Addendum No. 1
Four Rivers Sanitation Authority
Collection Systems Operations Facility
Structural Steel Package
Capital Project No. 2217

This Addendum Number 1, dated May 13, 2022, for the above referenced project, supersedes all contrary and conflicting information in the specifications and contract documents, which are hereby supplemented or revised as follows:

COLLECTION SYSTEMS OPERATIONS FACILITY
STRUCTURAL STEEL PACKAGE
Capital Project No. 2217
Bid Doc. No. 22-409

2 SOUTH ELEVATION
SCALE: NTS

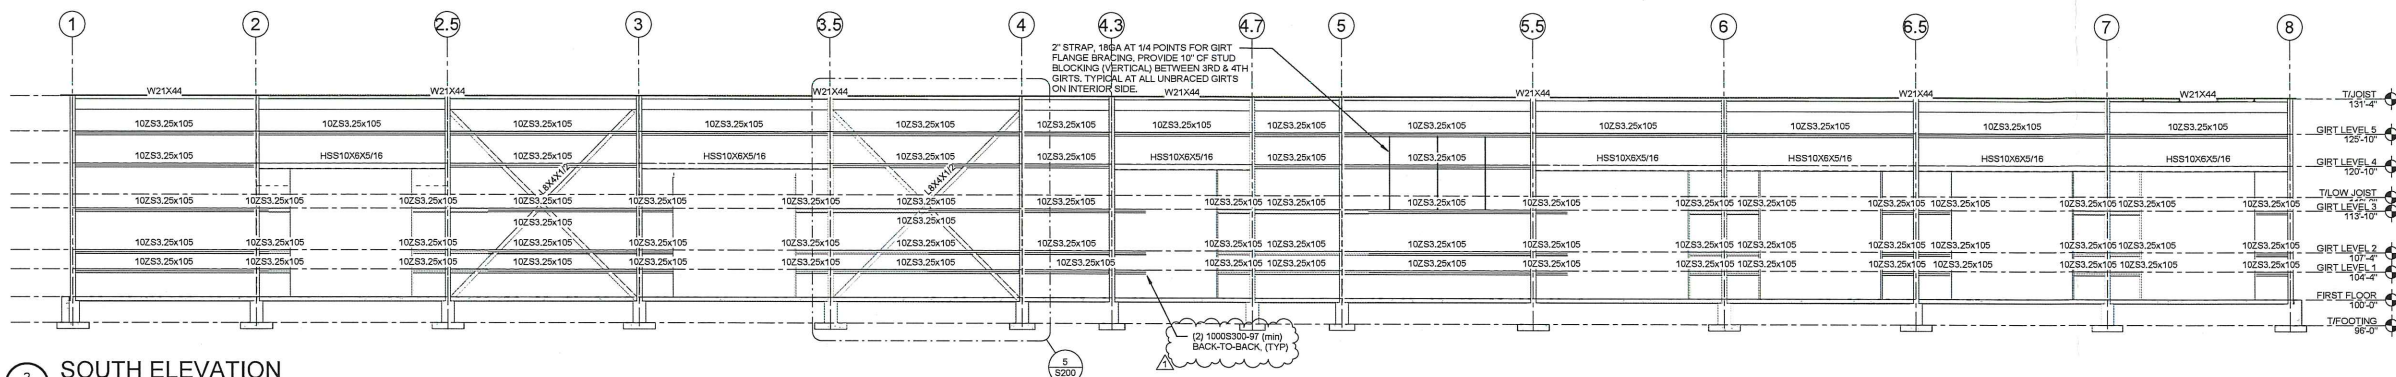
5. Per Detail 2 on Sheet S200 (south wall framing elevation) do you intend to provide a wall girt at +120'-10" elevation between column lines D/2.5 to D/3 and D/3.5 to D/4?

8. See Detail 2 on Sheet S200 (south elevation of wall framing); is this detail correct by showing wall purlins from column line D/4.8 to D/5.6, below elevation +116'? (This is where masonry is located for storage/janitorial/restrooms)

Response: *Yes. All 10ZS3.25x105 girts (including straps and insulated metal panel attachments) will be responsibility of the General Contractor and the wall panel system in future bid. All W-shapes, Steel L's and HSS shown on Details 1, 2, 3 and 4 on Sheet S200 are responsibility of the steel fabricator in this bid.*

Response: *Correct, wall girts will not be required at Masonry wall location. See Note 5 for additional notes relating to girts.*

5 TYPICAL X-BRACING
SCALE: NTS

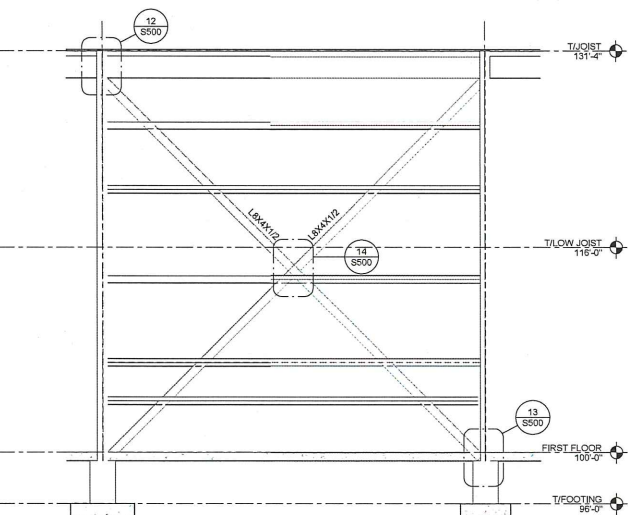
4. Per Detail 5 on Sheet S200: How do the 8"x4"x1/2" X-brace L's pass thru the wall girts?

Response: *Girts bypass columns on outside, X-brace is column centerline*
